**RESPONSE TO FEMA COMMENTS  
ON THE  
CONDITIONAL LETTER OF MAP REVISION  
(CLOMR)  
FOR  
THE GUBLER AVENUE BRIDGE  
ON THE MUDDY RIVER**

**451-003**

**Re: Case # 07-09-1164R – CLOMR for Gubler Avenue Bridge on the Muddy River**

GUBLER AVENUE BRIDGE CLOMR  
FIGURE 5  
TOPOGRAPHIC WORKMAP

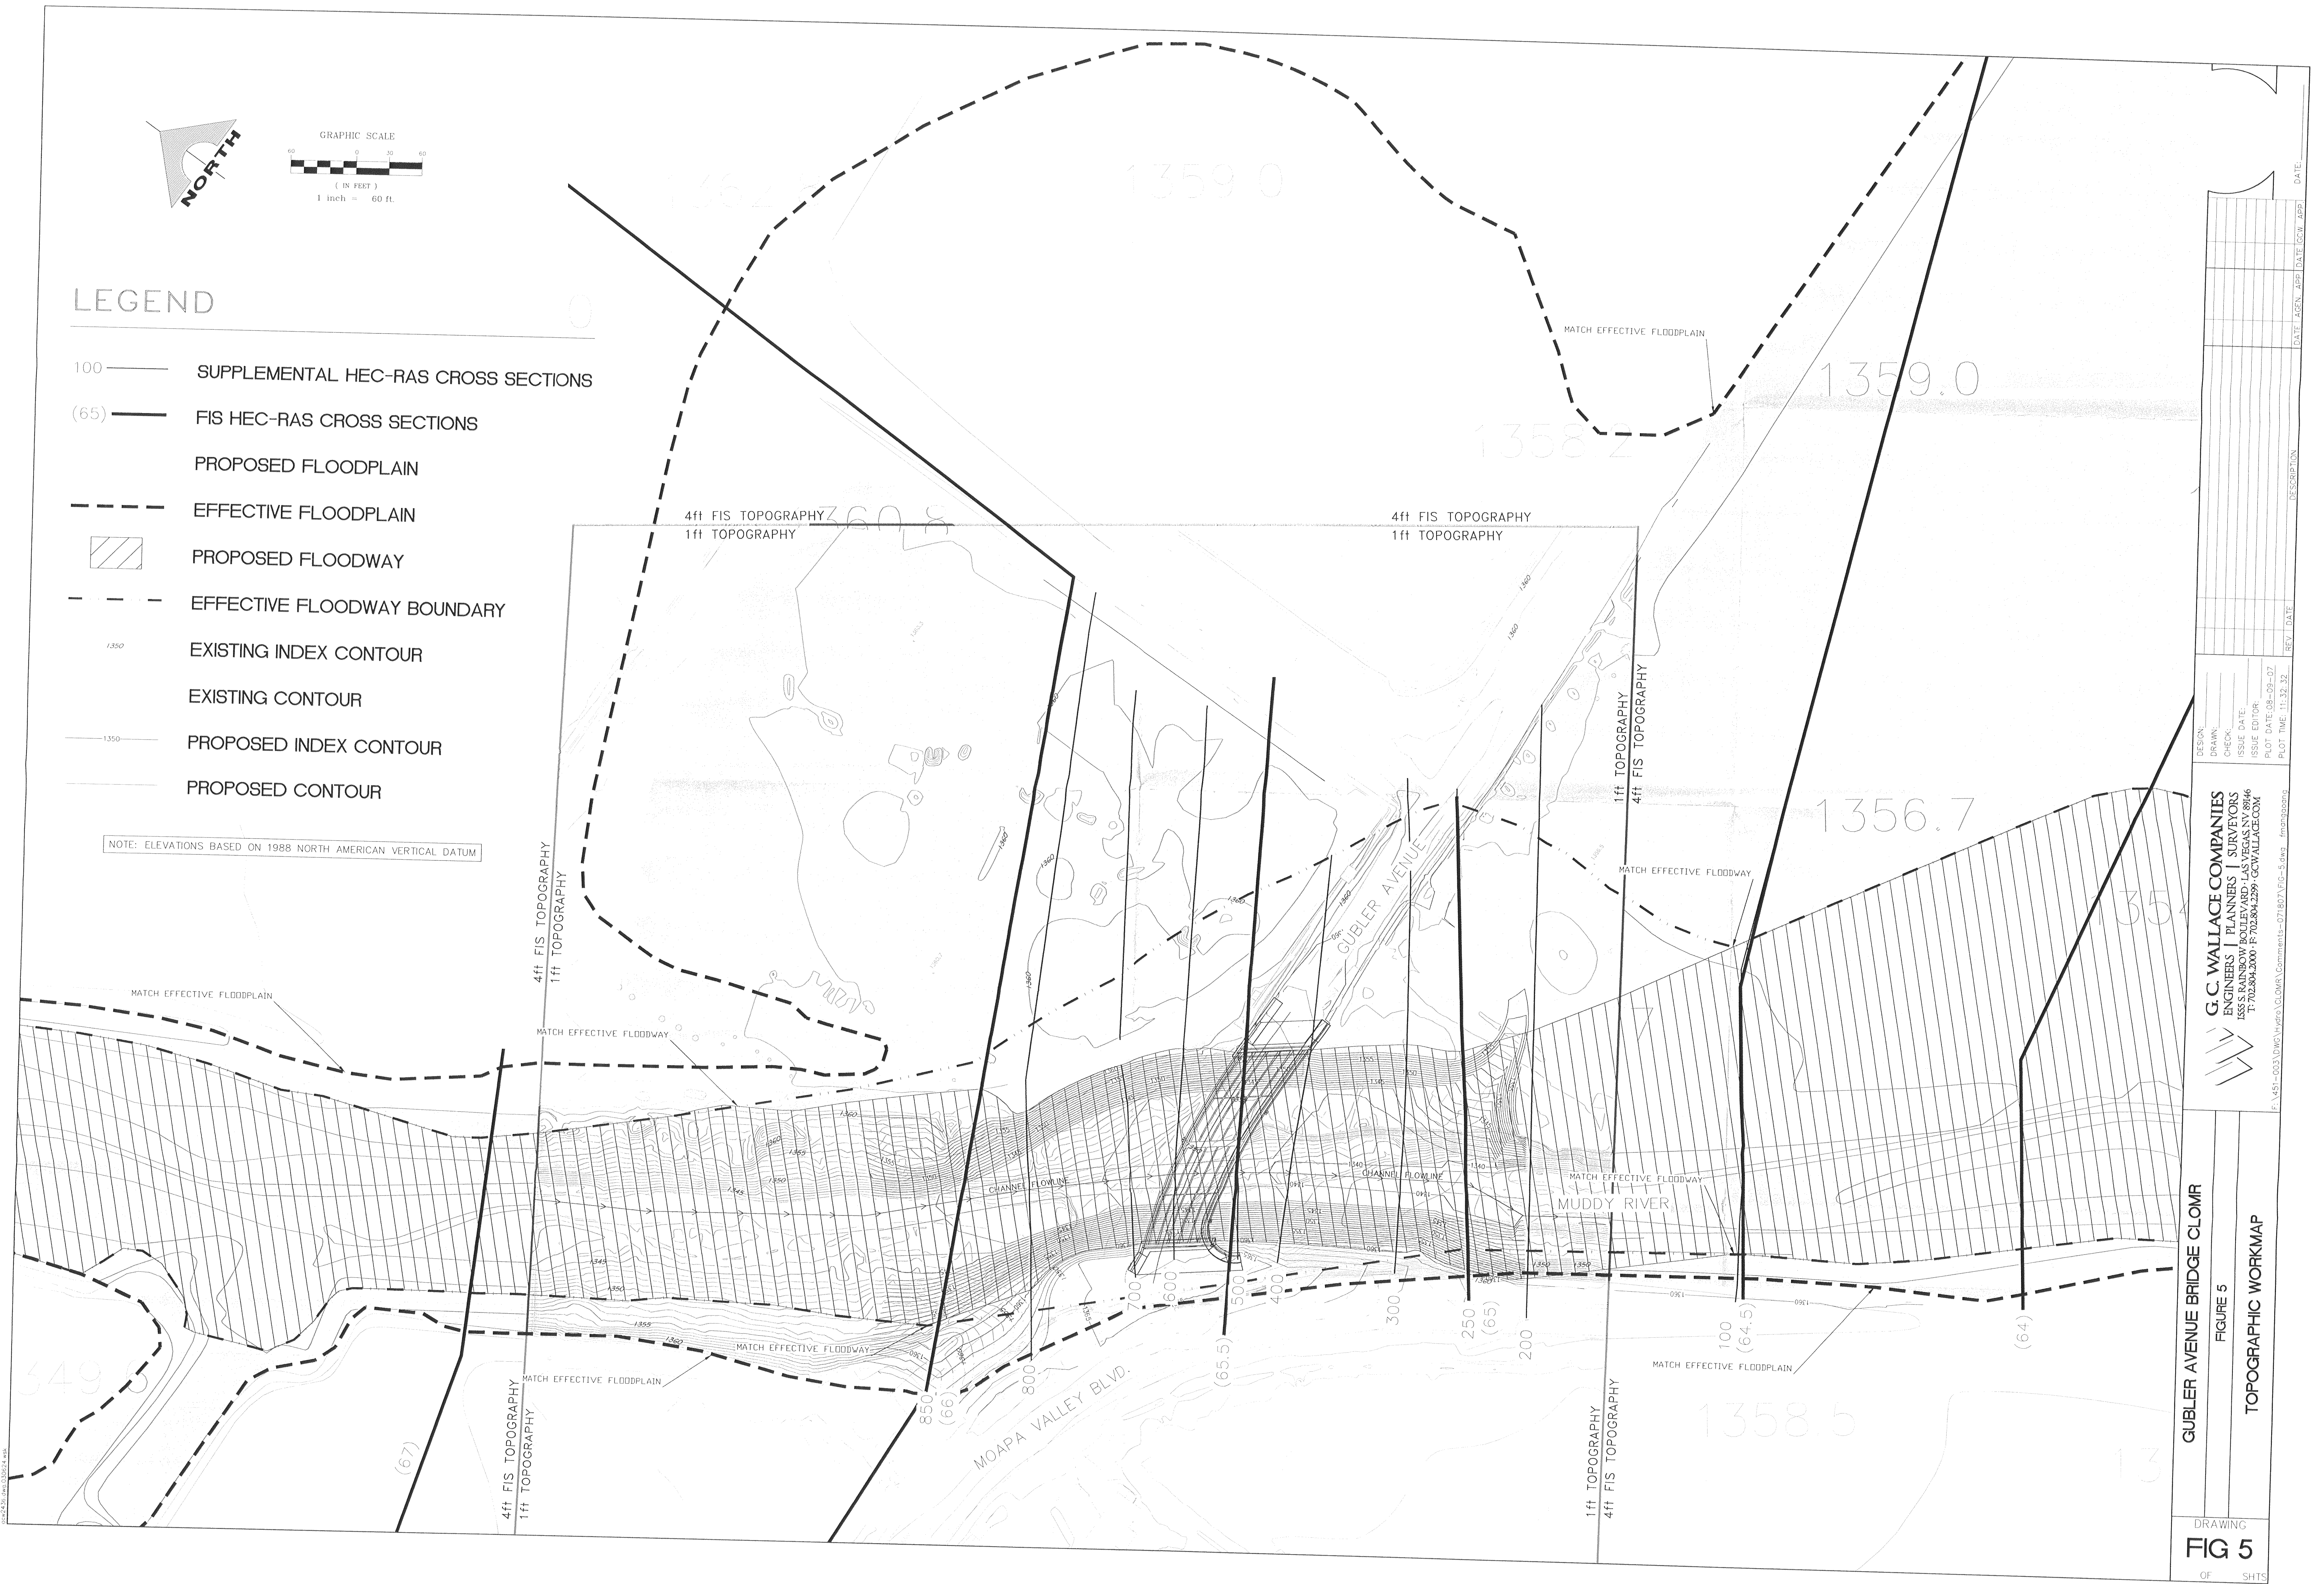
**Comment:** "1. The submitted map entitled "*GUBLER AVENUE BRIDGE CLOMR TOPOGRAPHIC WORK MAP, FIGURE 5*, prepared by G. C. Wallace Companies, dated April 5, 2007, does not provide essential information required to complete our detailed review of this request. Please provide the flow line used in the hydraulic model, which was omitted from the submitted topographic work map."

**Comment:** "2. The base floodplain and floodway top widths found in the submitted proposed conditions HEC-RAS hydraulic model for the Muddy River do not match the approximate base floodplain and floodway top widths shown on the above-referenced topographic work map at Cross-Sections 7100, 6800, 850, 800, 700, 701, 600, 500, 400, 399, 300, 250, and 200. For example, the base floodplain top width at Cross Section 7100 is approximately 200 feet on the previously mentioned topographic work map; however, it is approximately 414 feet in the submitted proposed conditions HEC-RAS hydraulic model. Please make the necessary revisions to ensure that the base floodplain and floodway top widths shown on the submitted topographic work map match the top widths found in the submitted proposed conditions HEC-RAS hydraulic analysis at all cross sections."

**Response:** The requested flow line has been added to the topographic work map. Please see the revised Figure 5 included in the appendix.

**Response:** Revisions have been made to the floodway and flood plain boundaries on the topographic work map and to the post-project conditions HEC-RAS model to bring them into better agreement. Note that changes to the HEC-RAS model are relatively minor and are confined to the overbank areas. The changes had little impact on the projected post-project flood elevations. A revised comparison table of

The revised Figure 4 and revised Figure 5 included in the appendix show the new limits of the floodplain and floodway boundaries. HEC-RAS model flow top widths and floodplain and floodway boundary top widths now agree within a tolerance of 5 feet at all cross sections within the CLOMR study area.
